Re: <u>557 Highland Avenue</u>, Needham Heights, Massachusetts (the "Property")

RESPONSES TO TOWN OF NEEDHAM PLANNING BOARD COMMENTS AT JUNE 7, 2022 PUBLIC HEARING (557 HIGHLAND AVENUE)

RESPONSE TO GPI COMMENTS ON TRANSPORTATION IMPACT AND ACCESS STUDY (557 HIGHLAND AVENUE)

From: Sean Manning, PE, PTOE Matthew Duranleau, PE Re: Response to Transportation Impact and Access Study Traffic Peer Review Comments dated May 27, 2022

Queue Diagrams

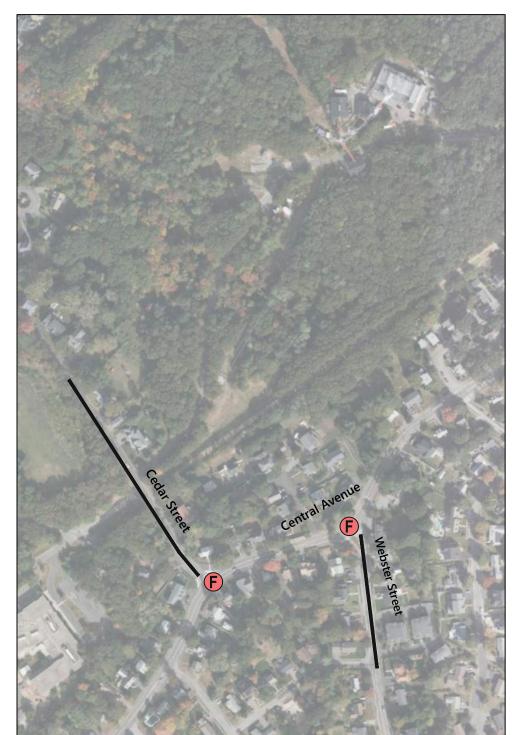
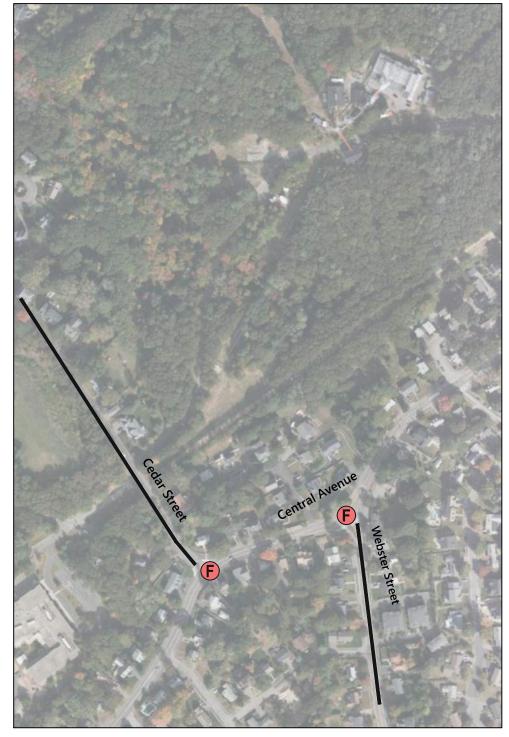
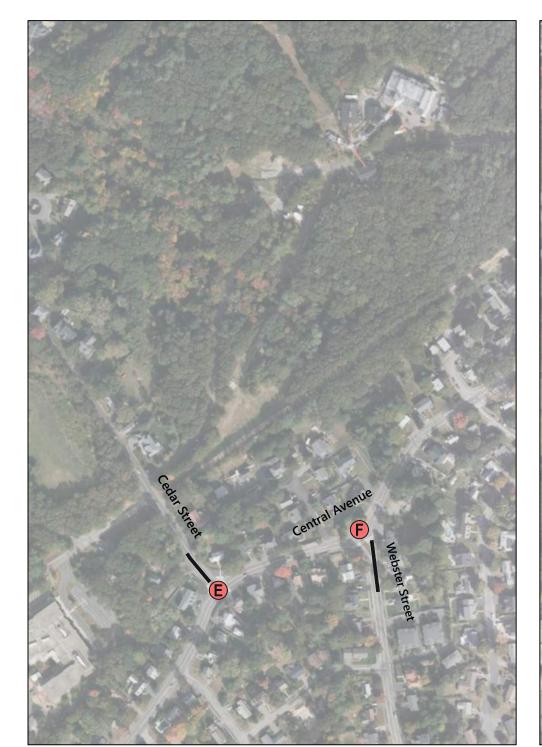
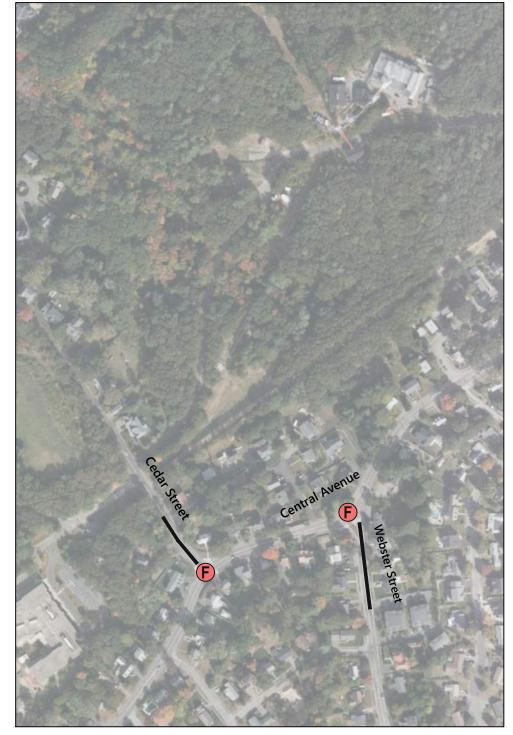
- 2. The project will also require a Vehicular Access Permit from MassDOT for the proposed change-in-use of the property, as well as for the construction of off-site roadway improvements within the SHLO. As such, the ENF was reviewed by the MassDOT District 6 office, as well as the Public-Private Development Unit (PPDU). The following comments from MassDOT were incorporated into the ENF Certificate issued by MEPA:
 - a. The Applicant should evaluate queuing at the study area intersections to ensure that lengthier queues do not impact the operation of roadways and railways within the study area.

<u>Applicant Response:</u> To understand the queueing impacts of operations at each study area intersection under the 2022 Existing Conditions, 2029 No Build Conditions, and 2029 Build Conditions, queue diagrams have been developed for the weekday morning and weekday evening peak hours. The queue diagrams for each study area intersection are provided in the Attachments to this memorandum.

Collision Diagrams

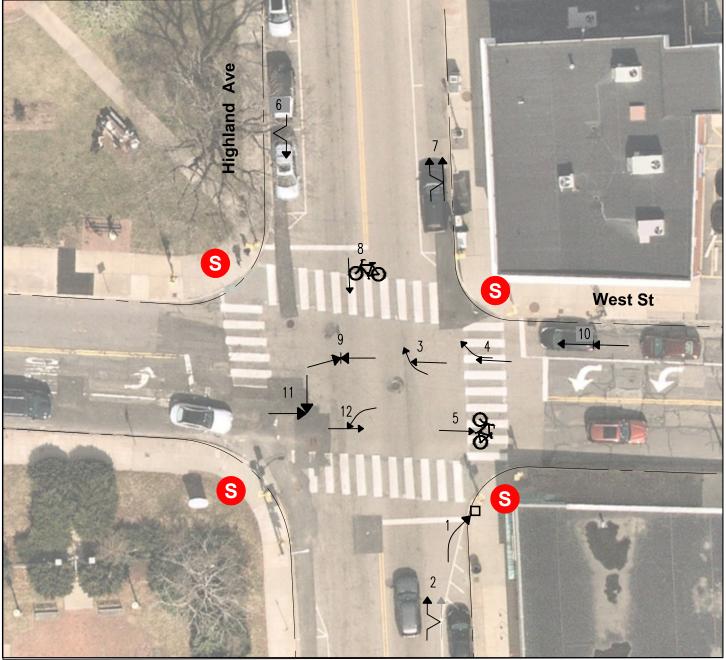
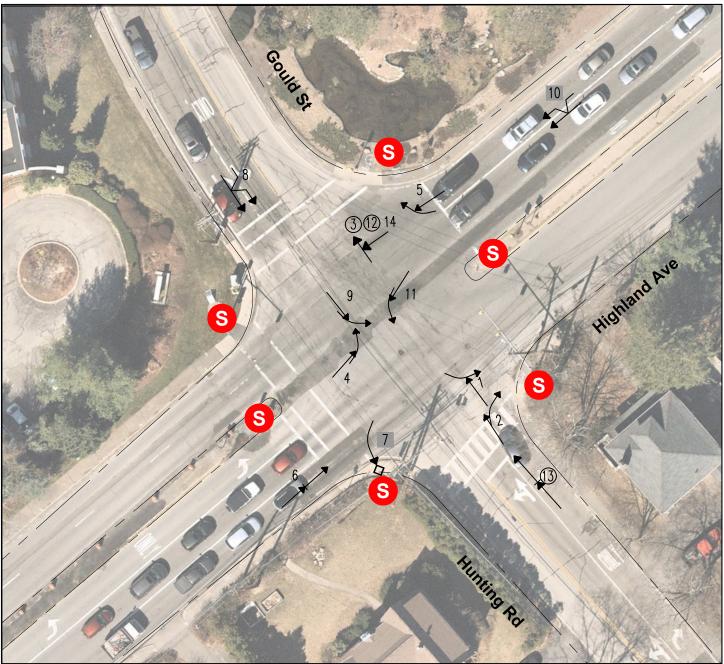
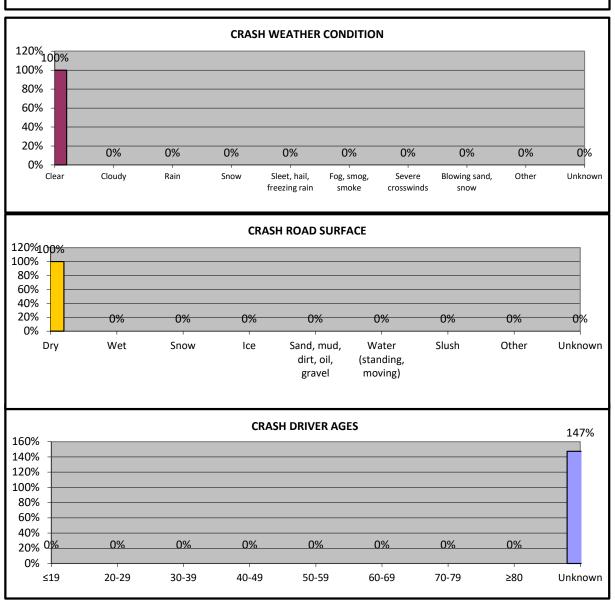
The high prevalent of angle crashes may indicate conflicts between turning vehicles and through vehicles. This could be caused by drivers becoming frustrated with congestion and trying to turn when there are insufficient gaps in opposing traffic. To improve operations and reduce congestion at the three intersections where collision diagrams were developed, signal timing modifications are proposed as mitigation.

<u>Applicant Response:</u> As noted in the response to Comment 8, a collision diagram was developed for the intersection of Hunting Road at Kendrick Street. A collision diagram was not developed for the intersection of Highland Avenue at 1st Avenue, as that location was recently reconstructed which is not fully reflected in the crash data.

Comment 19

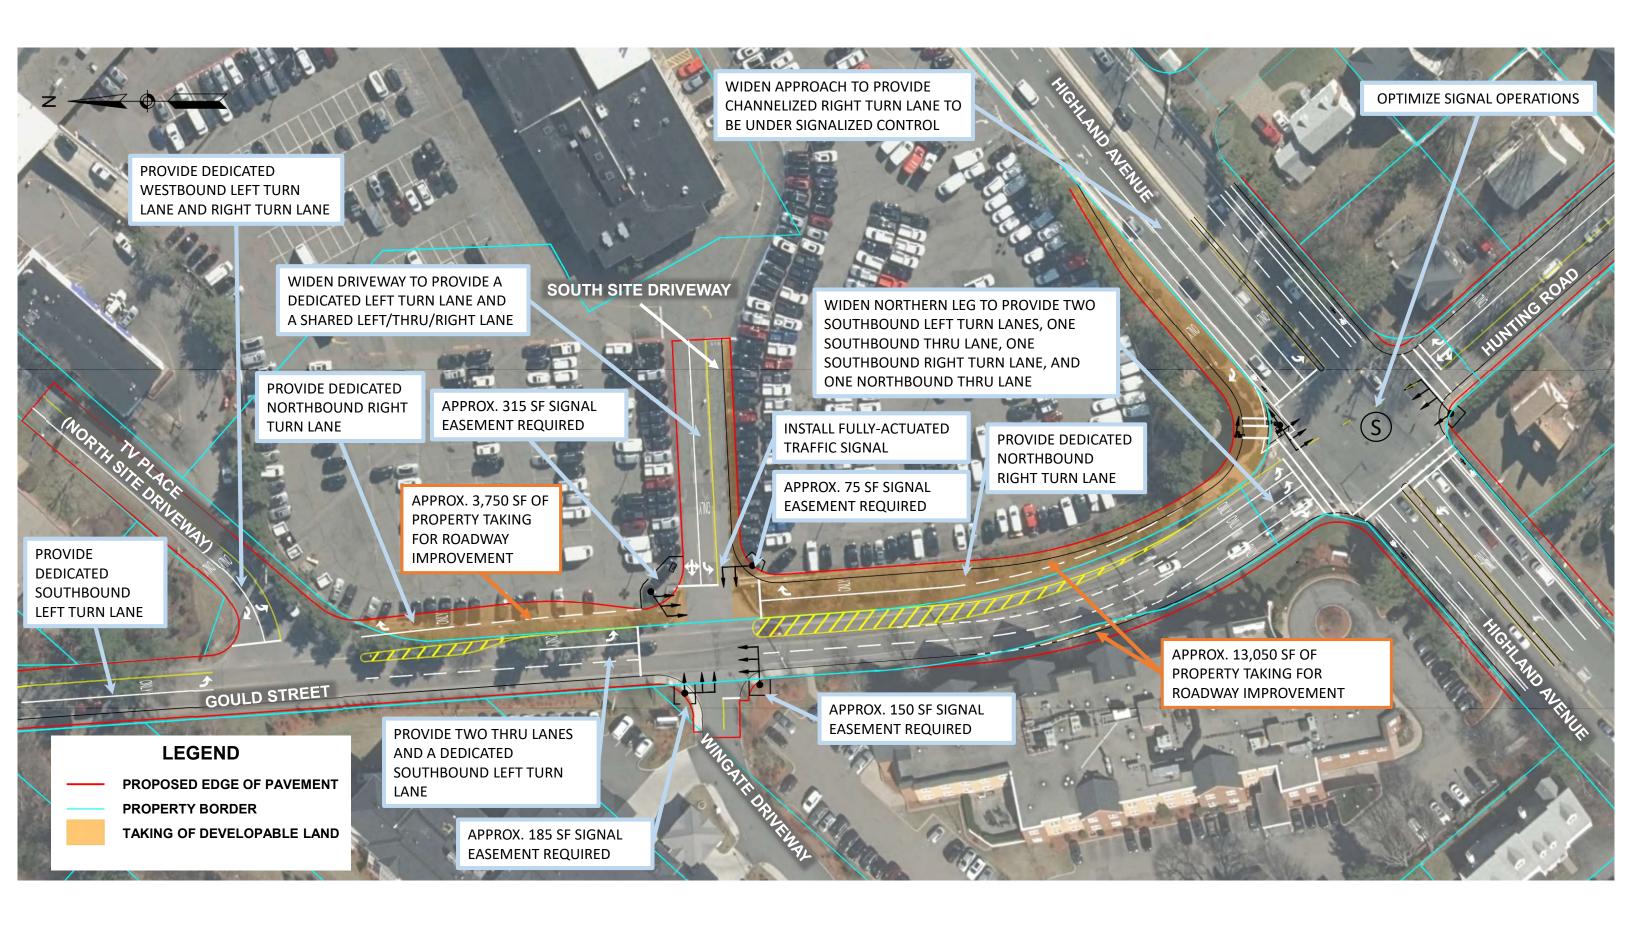
19. Figure 16 of the TIAS provides a graphic depiction of the roadway geometry proposed at the intersection of Highland Avenue / Gould Street / Hunting Road and along Gould Street fronting the site. The Figure does not include the Highland Avenue eastbound or Hunting Road northbound approaches to the intersection, so it is difficult to identify what, if any, improvements are proposed on those approaches. However, Figure 1.4 of the ENF also provides a similar graphic that includes all approaches to the intersection. While the geometry on the majority of the approaches appears consistent with the conceptual improvement sketches prepared as part of the former rezoning effort, the Hunting Road northbound approach to Highland Avenue and the

receiving approach on Gould Street are inconsistent with the rezoning plans. The analysis and plans prepared as part of the rezone indicated that two through lanes would be required on Hunting Road with two receiving lanes on Gould Street to accommodate the traffic generated by the project. The capacity and queue analysis summarized in Table 15 of the TIAS indicates that even with the mitigation measures proposed by the Applicant, the Hunting Road northbound movement will operate over capacity at level-of-service (LOS) F during the weekday AM and PM peak hours under 2029 Build with Mitigation conditions. The Highland Avenue eastbound left-turn movement will also operate at LOS F during the weekday AM peak hour. Therefore, the Applicant should consider the feasibility of providing an additional northbound lane on Hunting Road to improve the capacity and operations of this intersection.

Applicant Response: The conceptual improvements proposed as part of the rezoning of the Site were reviewed when developing the mitigation for the Project. The traffic study submitted by GPI for the rezoning of the Site included a conceptual improvement plan at the intersection of Highland Avenue at Gould Street/Hunting Road that included two lanes on the Hunting Road northbound approach, a shared left-turn/through lane and a right-turn lane, and one receiving lane on Gould Street north of the intersection. This geometry matches what is currently proposed by the Proponent. As noted in the ENF, the only difference between the previous concept plan and the plan proposed in the TIA is the exclusion of a dedicated right-turn lane on the Highland Avenue westbound approach, as adding a right-turn lane would introduce a weaving conflict between vehicles on Highland Avenue westbound and vehicles on the I-95 southbound off-ramp that would cause safety concerns. A figure of the concept plan from the GPI traffic study supporting the rezoning of the Site is included in the Attachments of this memorandum for reference.

While expanding the Hunting Road cross-section would provide additional capacity at the intersection, an additional northbound lane cannot be implemented without taking significant property outside of the right-of-way. This would have a major impact on the property at 580 Highland Avenue and could require the razing of the existing house on that property. Therefore, to limit the right-of-way impacts, no expansion of Hunting Road is proposed.
